*Ducted Systems
Technical Services
Service Tips Letter*

Letter: **ST-009-2018**

Subject: **New Burner Box Shoot Thru Plate**

Product: All 33" 90% Condensing Model Furnaces

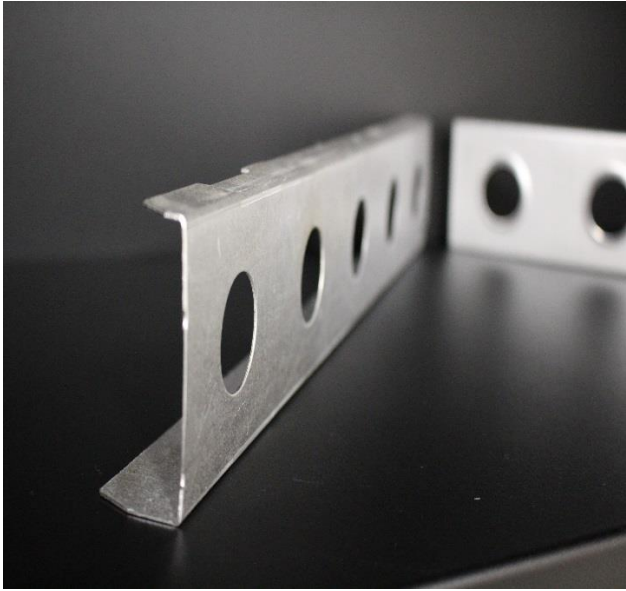
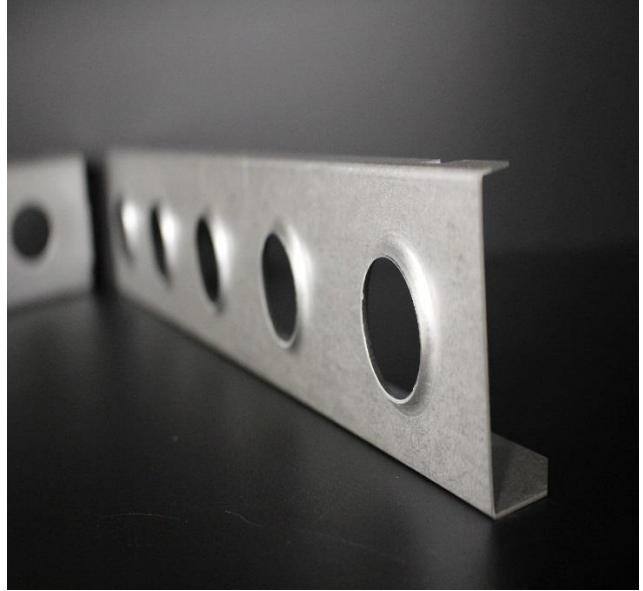
This heating season we received a small volume of calls concerning loud burner noise on condensing model furnaces. After researching this condition we came to the conclusion the air flowing through the burners into the heat exchanger was not transitioning smoothly. Based on this information the team worked on a new design for the shoot thru plate that allows the air to flow through the burners into the heat exchanger with less turbulence, resulting in quieter operation.

All condensing model furnaces produced since mid-April 2018 have the newly designed shoot thru plate. So any units with a W1E8 code date will contain the new shoot thru plate. Note that each Btu input model furnace has a unique shoot thru plate.

Listed below are the Source 1 part numbers for the new shoot thru plates that are now available for purchase:

2 Cell	S1-37339494001
3 Cell	S1-37339494002
4 Cell	S1-37339494003
5 Cell	S1-37339494004
6 Cell	S1-37339494005
7 Cell	S1-37339494006
